Access Compliance Report

Public Rights-of-Way

Intersection ID: 24596	Main Street: JARDINIERE_CT	Cross Street: SEQUOIA_RED_LN	Location: SW
ADA ID: 27473913BCBB	Ramp Type: BlendTrans2	Initial Pass/Fail: Pass	Overall Compliance: No
Severity Score: 7.75			
Codes/Mitigation Info/Possible Solution		Field Measurements/Component Compliance

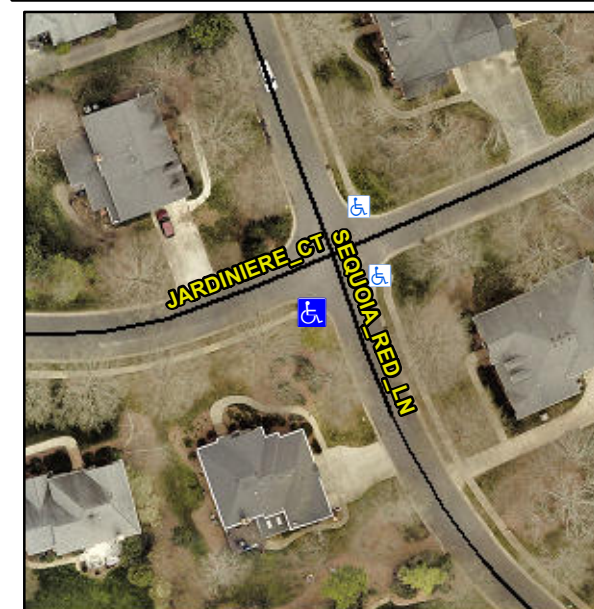
ASP LIP 0.5

Not Found, R304.5.3, R305.1.4, R305.2, R304.5.4

Remove & Replace Curb Ramp With Two New Directional Ramps or Equivalent. Remove & Replace Gutter.
